Planning Board

RE: Referral from Village Board for a recommendation on Local Law Introduction 11 of 2022 revisions to the Zoning Law to expand the Harmon/South Riverside Gateway area and to modify the regulations for that area to encourage Residential development and

Referral from Village Board for a recommendation on Local Law Introduction 12 of 2022 revisions to the Zoning Law to modify the regulations for the LI zoning district in the area near the Metro-North Croton-Harmon Train Station to allow for transit-oriented development.

DATE: September 23, 2022

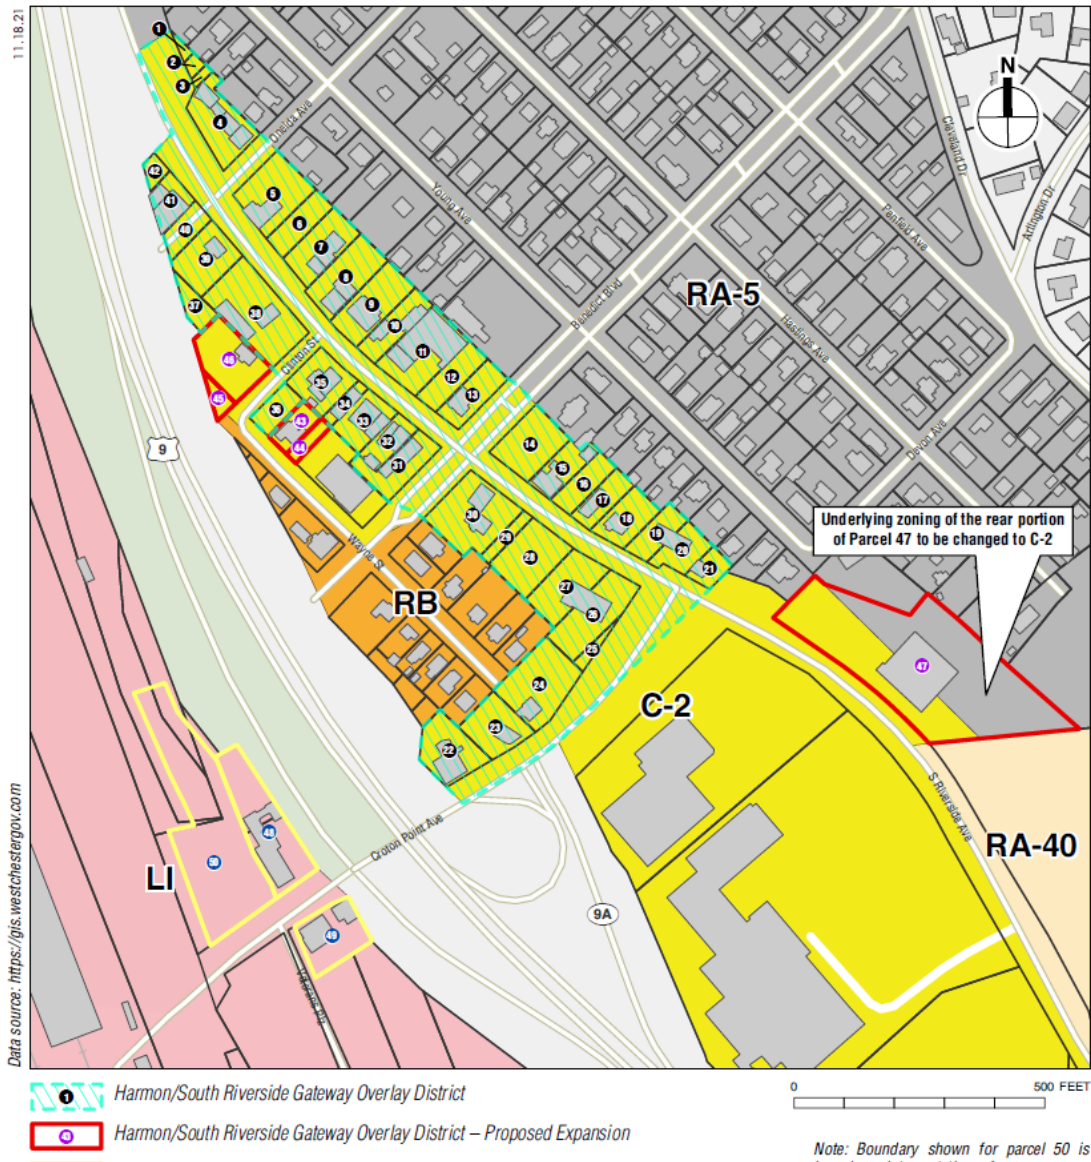
The Harmon/South Riverside Gateway Overlay District is proposed to be expanded to include five additional parcels. Two parcels on Clinton Street, two on Wayne Street and one on South Riverside Avenue across from ShopRite. The parcels to be added are shown outlined in red in the image below.

Planning Board is in favor of expanding the Gateway Overlay district to include these additional five parcels as indicated below.

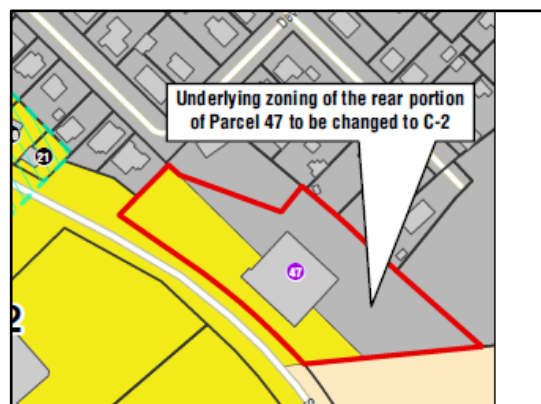
The draft local law also proposes to rezone the rear portion of parcel 47 (shown in image below) from RA-5 to C-2.

The Planning Board notes that parcel 47 is currently a split-zoned parcel with the portion along South Riverside Avenue zoned C-2 and the rear portion zoned RA-5. Section 230-7A(4) (see below) of the Zoning Code addresses lots that have split zoning.

The latest site plan (see image of portion of site plan below) for parcel 47 indicates that greater than 50% of the parcel is zoned C-2 so as per section 230-7A(4) of the Zoning Code the C-2 regulations would currently apply to the rear portion of parcel 47. The rezoning of the entire parcel to C-2 would make the applicable zoning regulations clear on the zoning map and for those intending to develop the parcel. The Planning Board is in favor of the rezoning of the rear of parcel 47 to C-2.

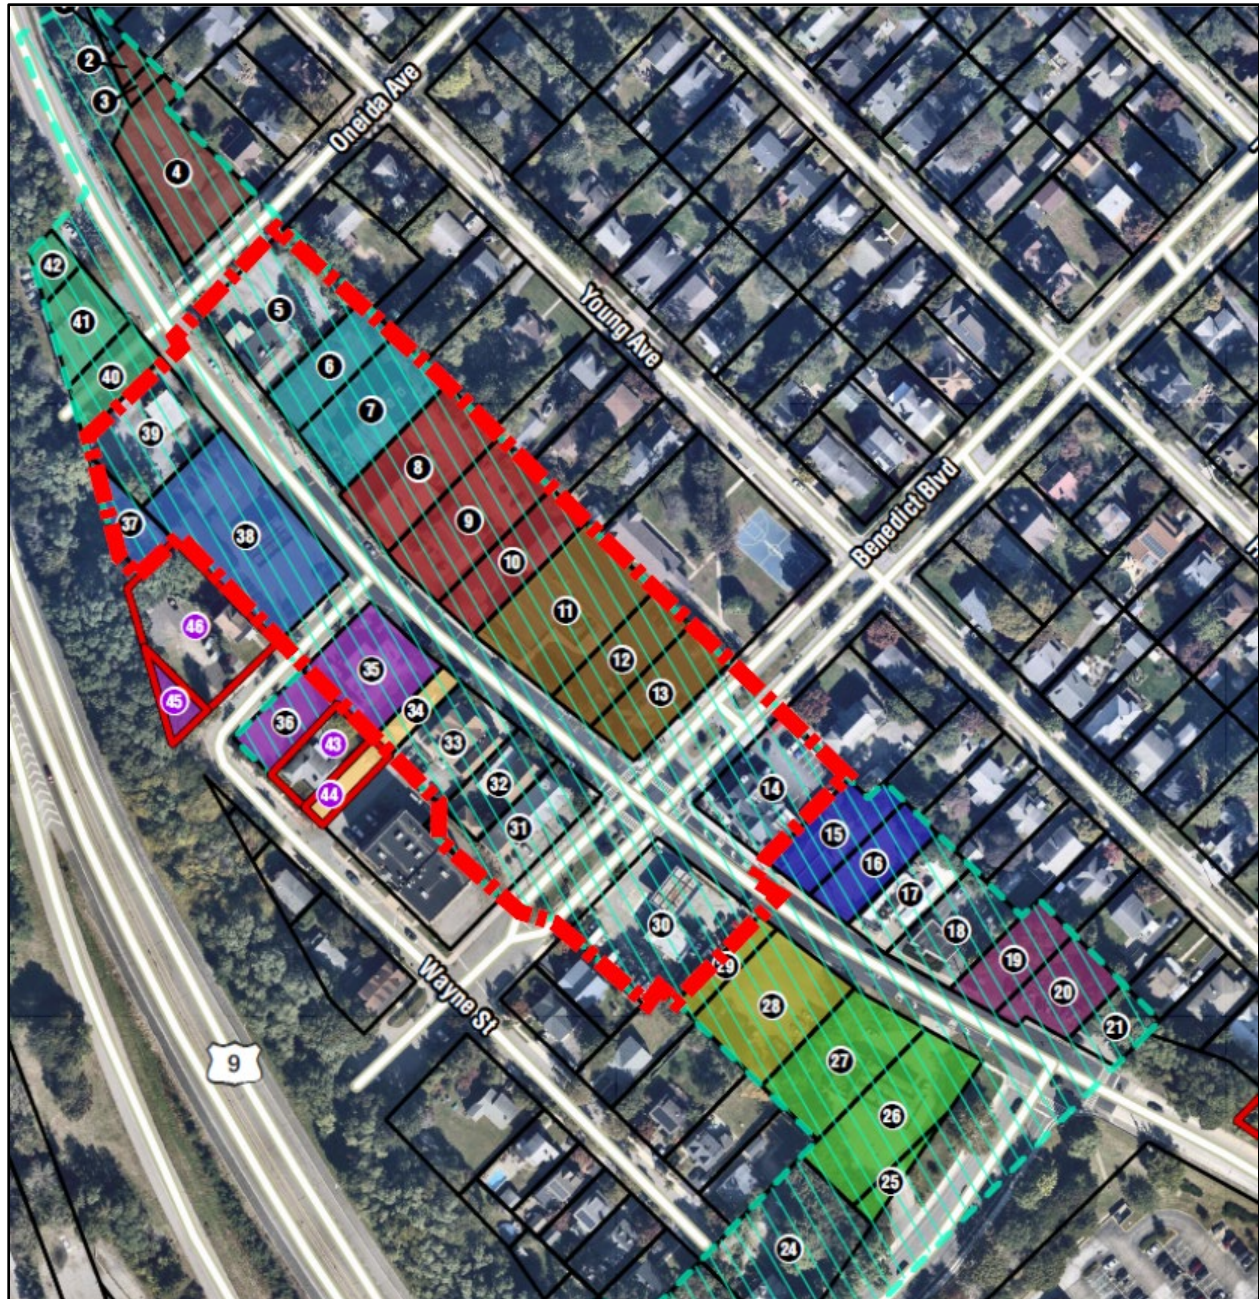
The Planning discussed the option of prohibiting the proposed multi-family use from certain areas of the Harmon/South Riverside Avenue gateway overlay district. This concept was used when rezoning the North Riverside neighborhood area as shown in the image below from the *Municipal Place Gateway and North Riverside Neighborhood Zoning Study (October 2019)*. Multi-family buildings were prohibited in the core business area, C-1R(A) zoning district, and limited to the transition areas, C-1R(B) zoning district, leading into the core business area.

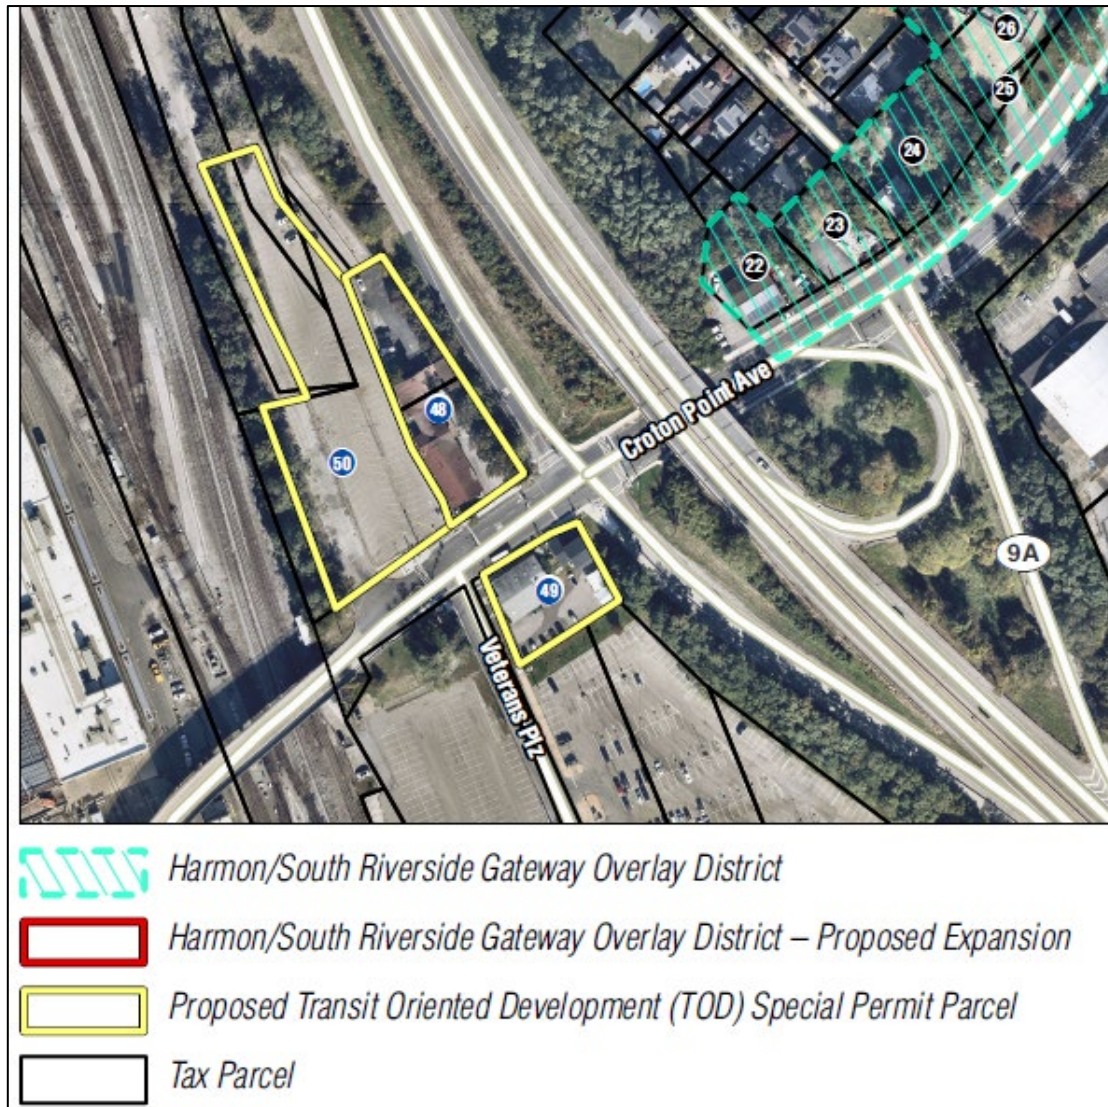
The allowable uses in the Light Industrial Zoning District are proposed to be expanded to include Transient Orientated Development (TOD) on three parcels on Croton Point Avenue just west of Route 9: parcels 48, 49 and 50; as shown in the image below.

The Planning Board felt that this was an excellent area for TOD given the proximity to the Croton-Harmon Train Station, parks, food stores and other business. It was noted that mixed-use and multi-family buildings with an FAR of 1.2 and five stories would be permitted in the proposed TOD area in the LI district. The Planning Board reviewed the viewshed analysis for the five-story building and agreed that a five-story building would not present a significant adverse visual impact when view from residences on Young Avenue and Hastings Avenue and adjacent streets.
